ADDENDUM No. 1
Central Avenue Stormwater Improvements
CITY OF LAKE STATION
PROJECT NUMBER: 2022.00047

OCTOBER 14, 2025

CITY OF LAKE STATION
1969 CENTRAL AVE.
LAKE STATION, IN
46405

ROAD
TYPICAL SECTIONS
C-203

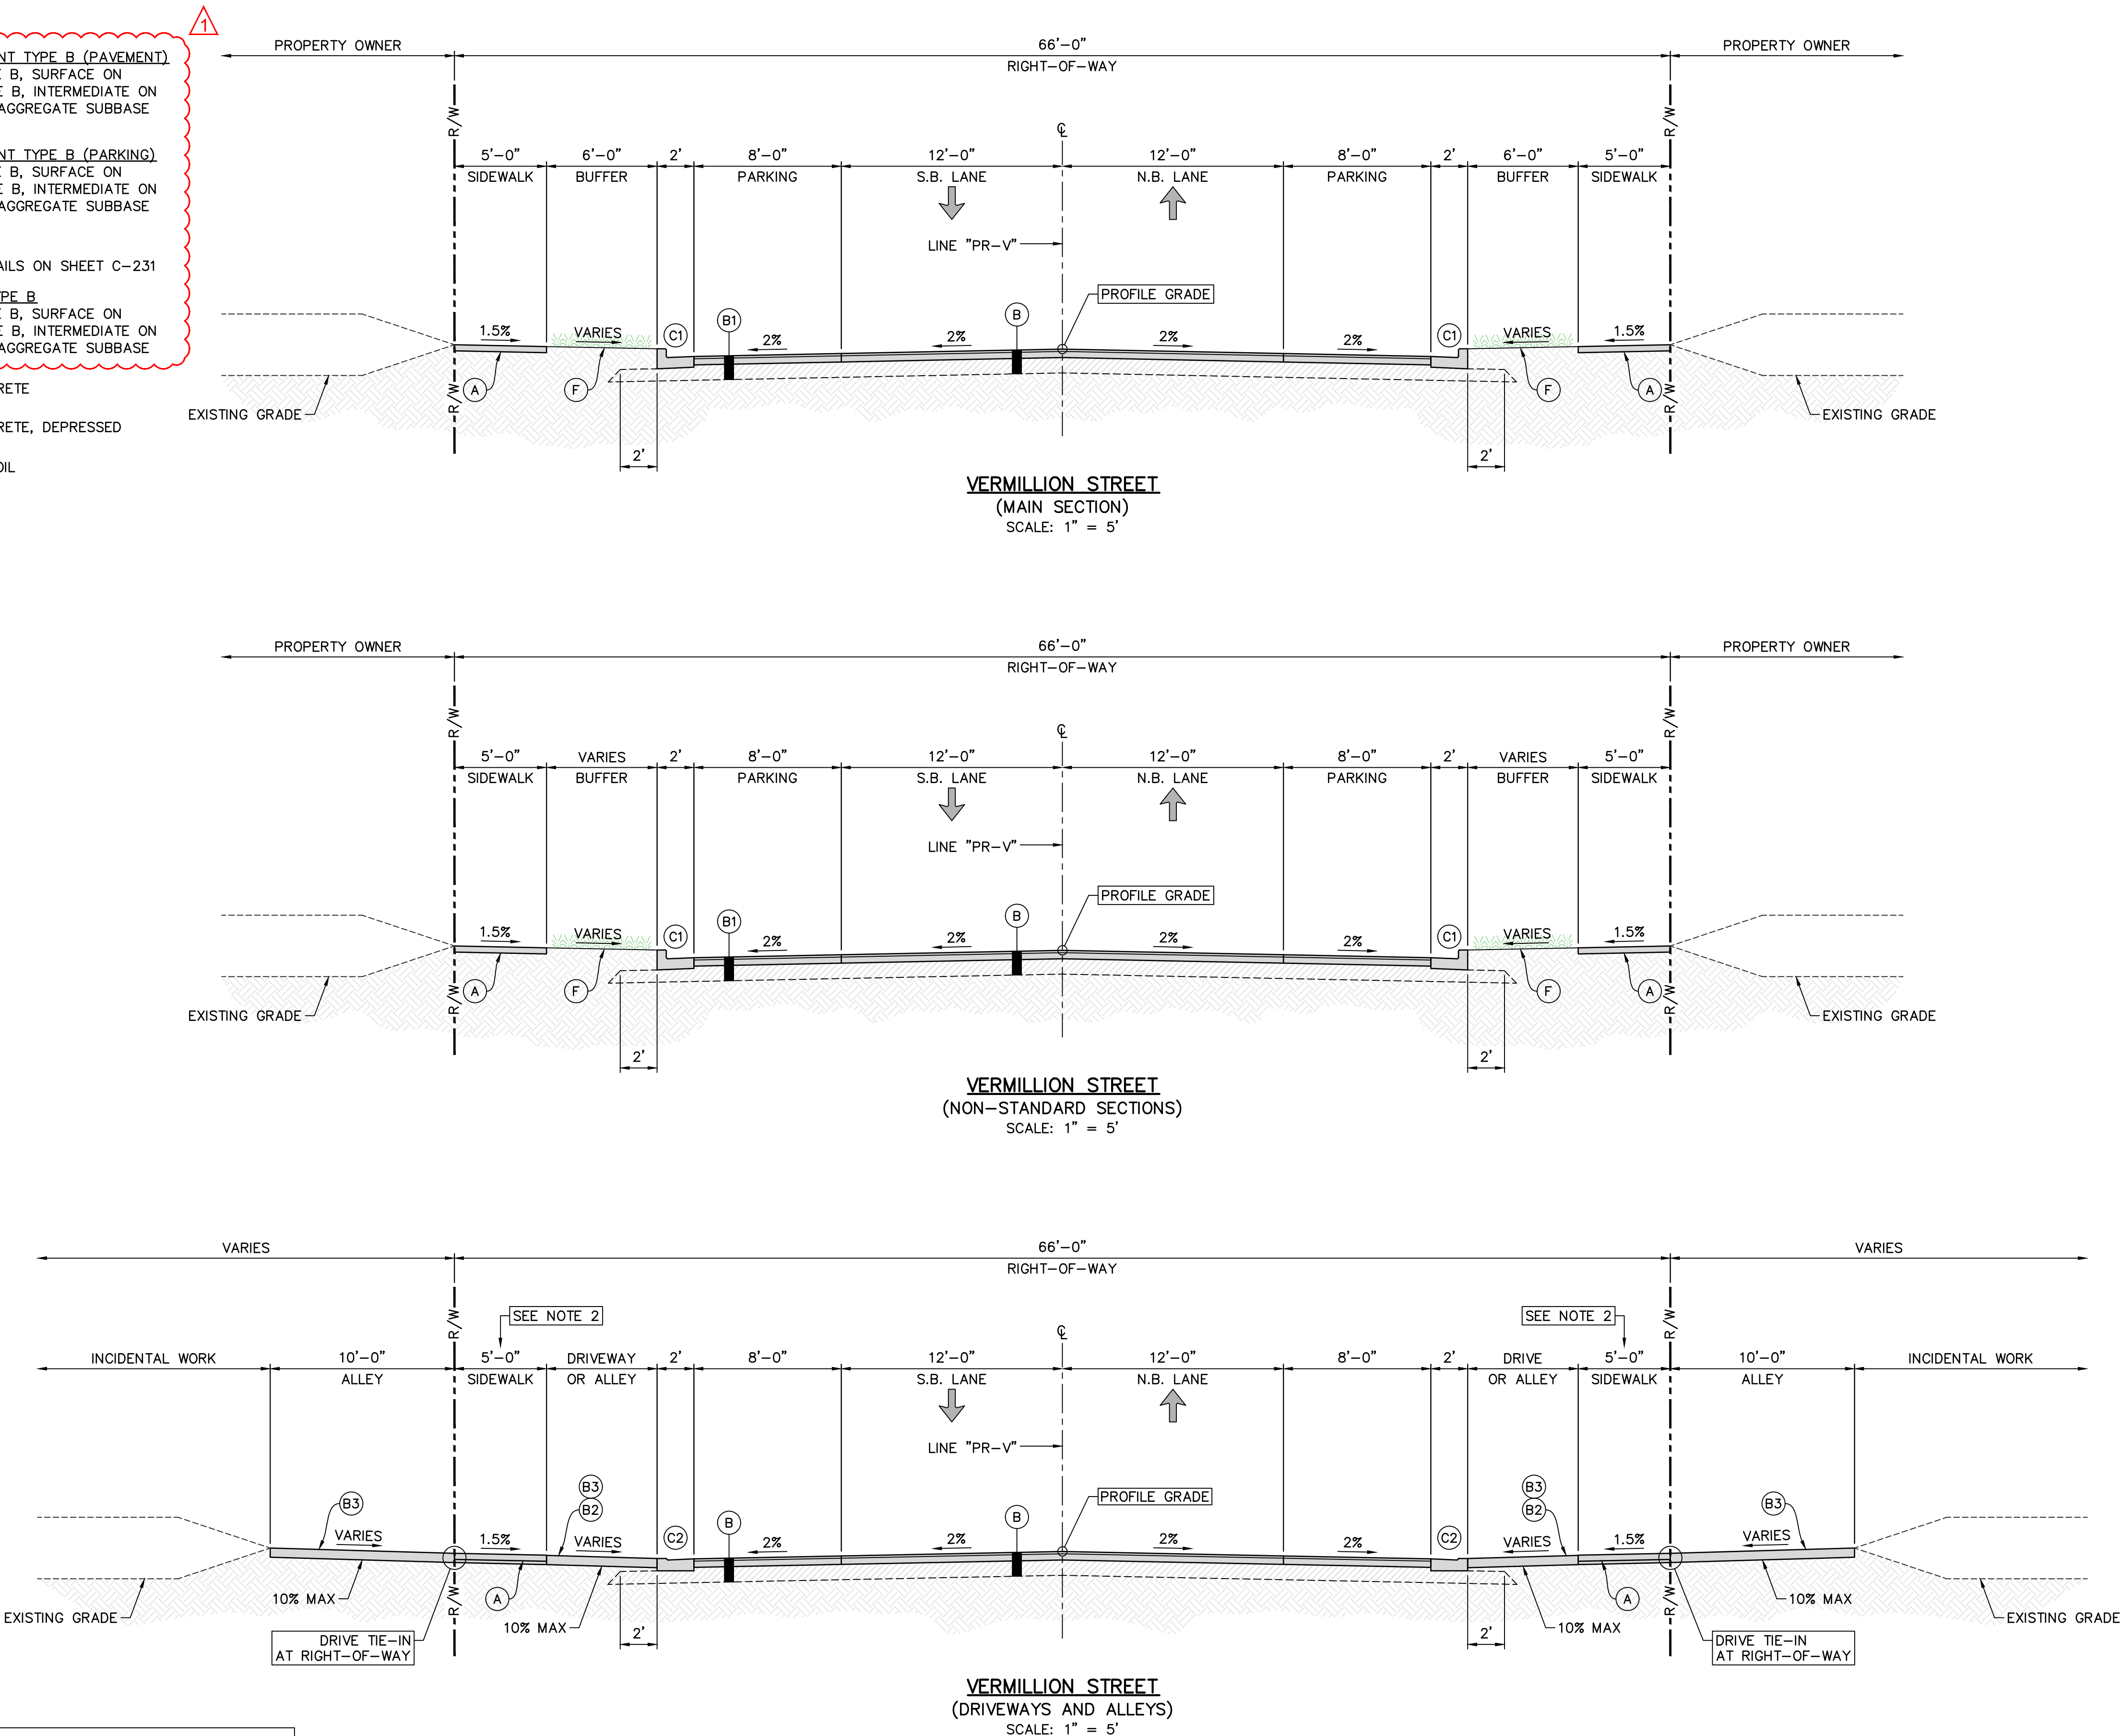
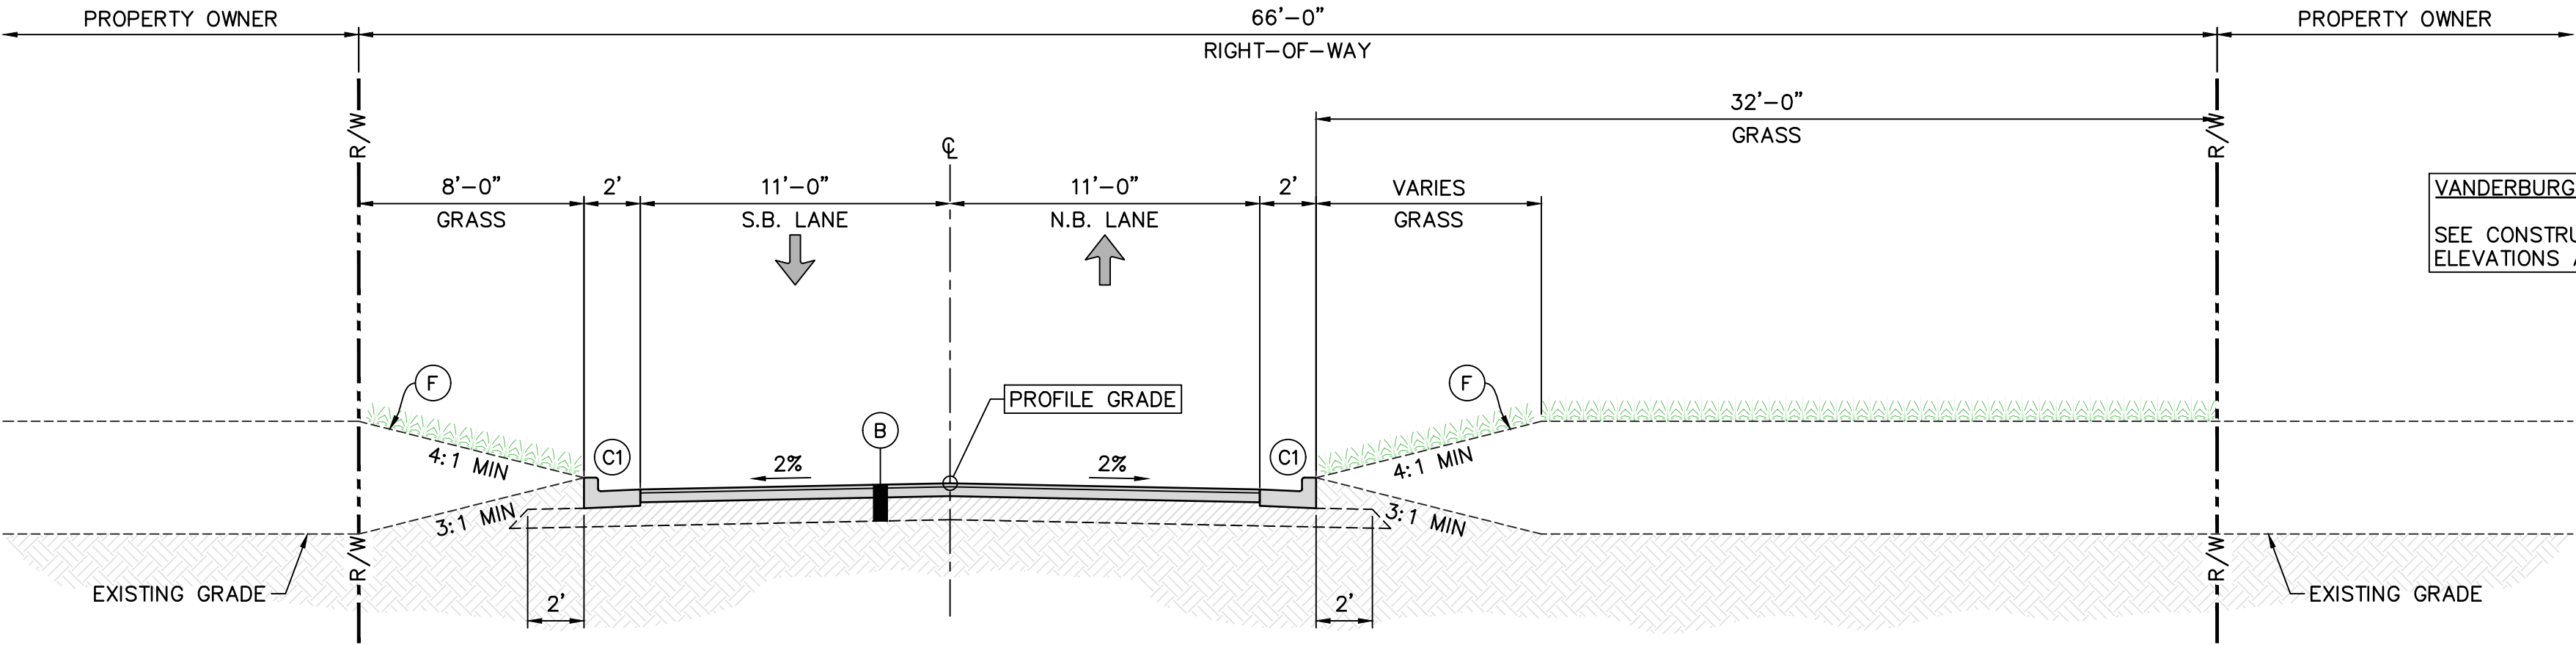
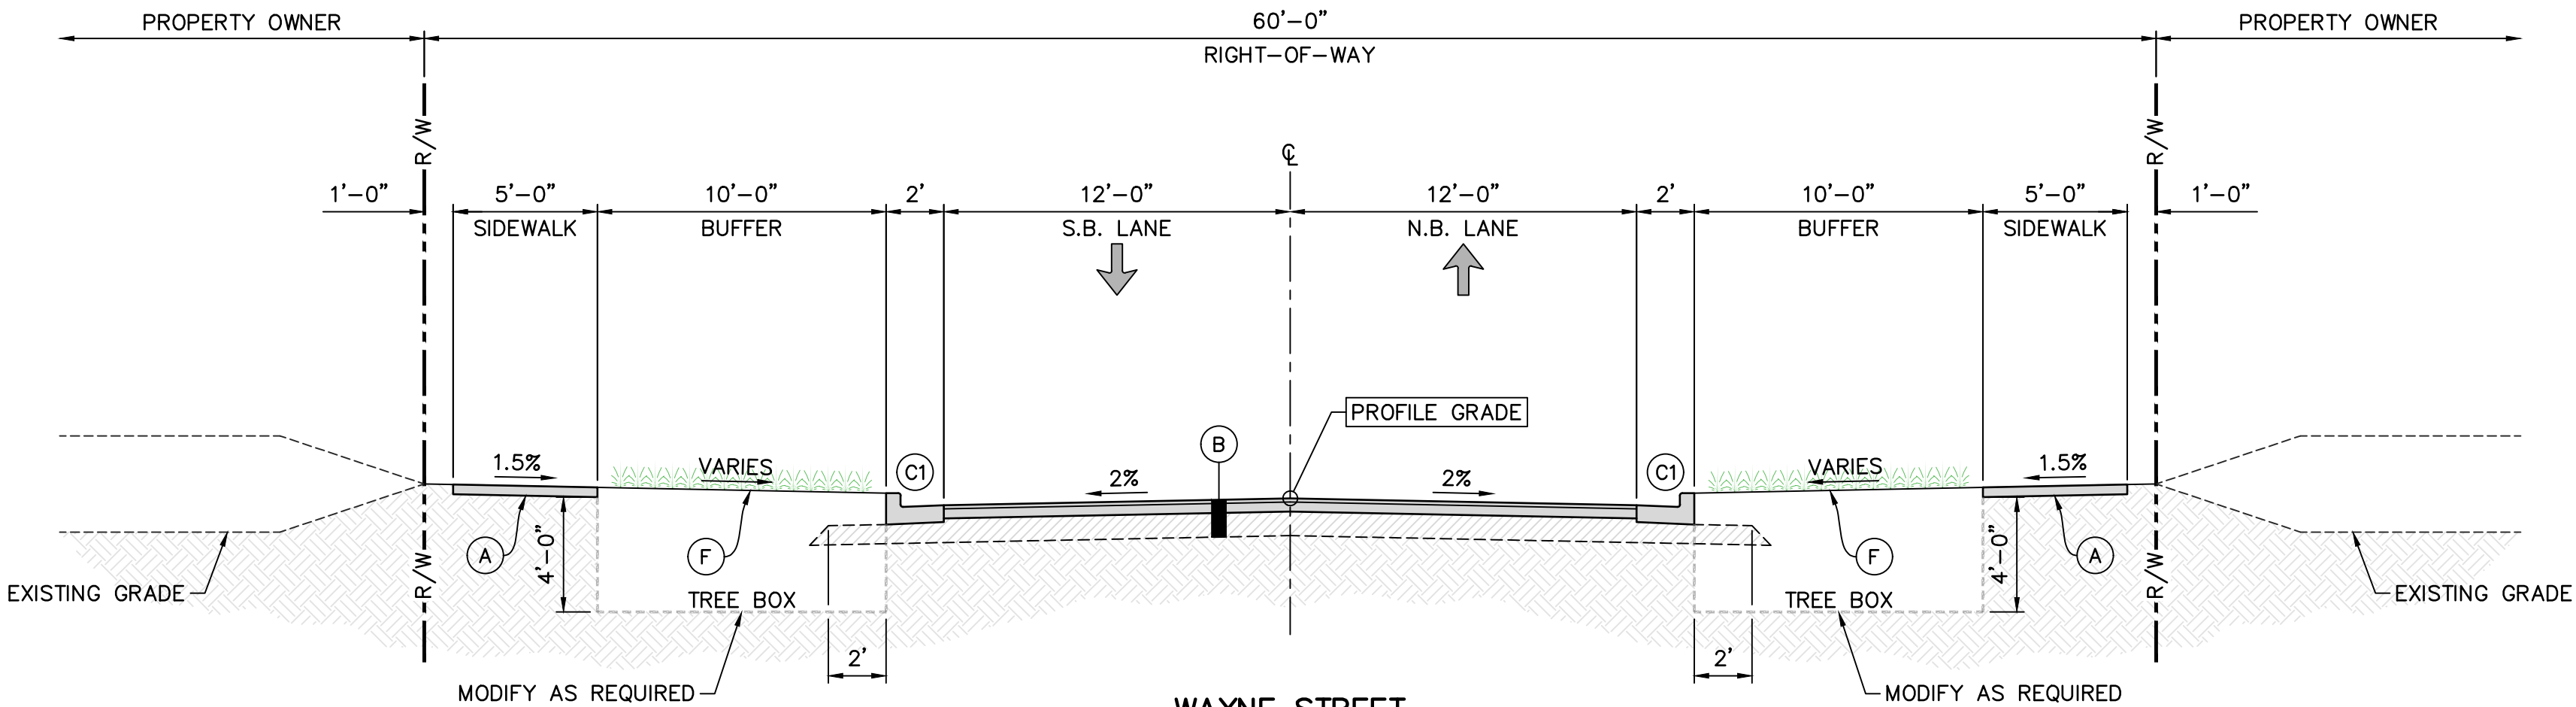
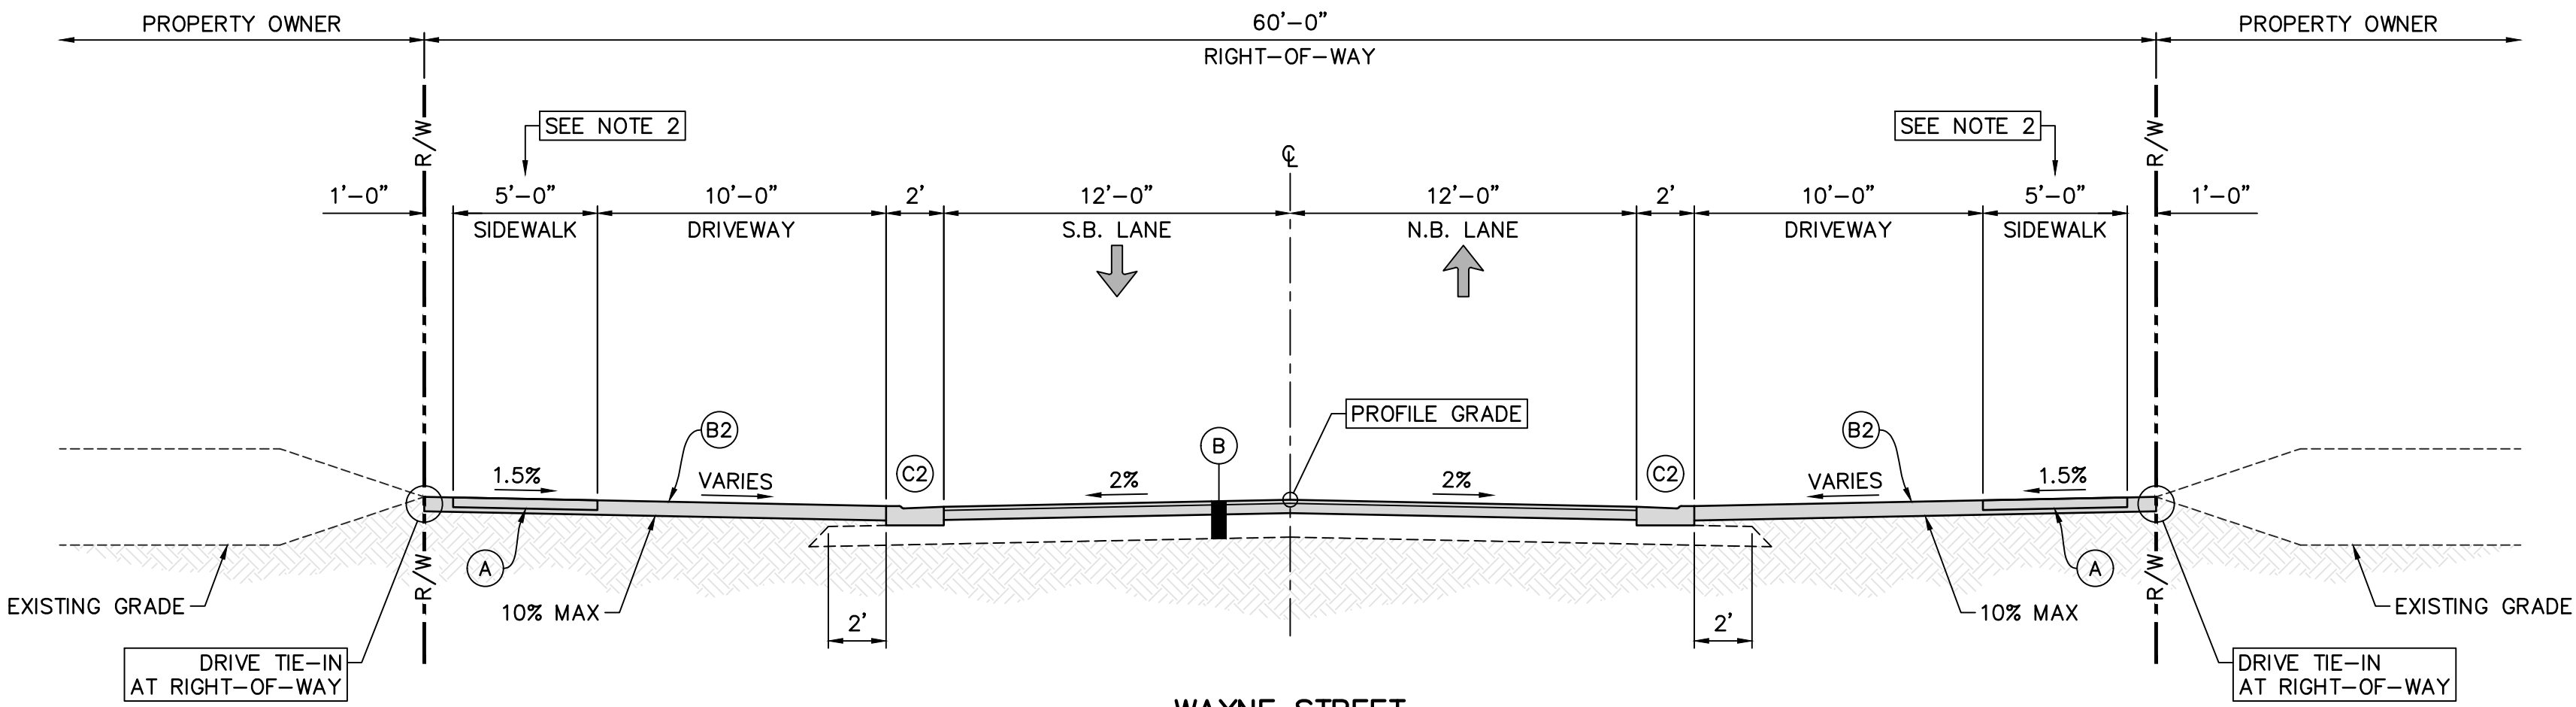
30. **Question:** C-203 states that the depth of the milling may be greater to achieve 2% slope on Central Ave: Will the engineer provide curb elevations for the work on Central Avenue?

31. **Question:** C-203 states that the depth of the milling may be greater to achieve 2% slope on Central Ave: Will the Engineer provide revised elevations based on actual road elevations?

32. **Question:** C-203 states that the depth of the milling may be greater to achieve 2% slope on Central Ave: Will this additional depth be paid separately?

Answer: No

Answer: Revised elevations will be provided by the Engineer as required.

Answer: Yes, if approved by the Owner and Engineer, then it will be paid for separately.
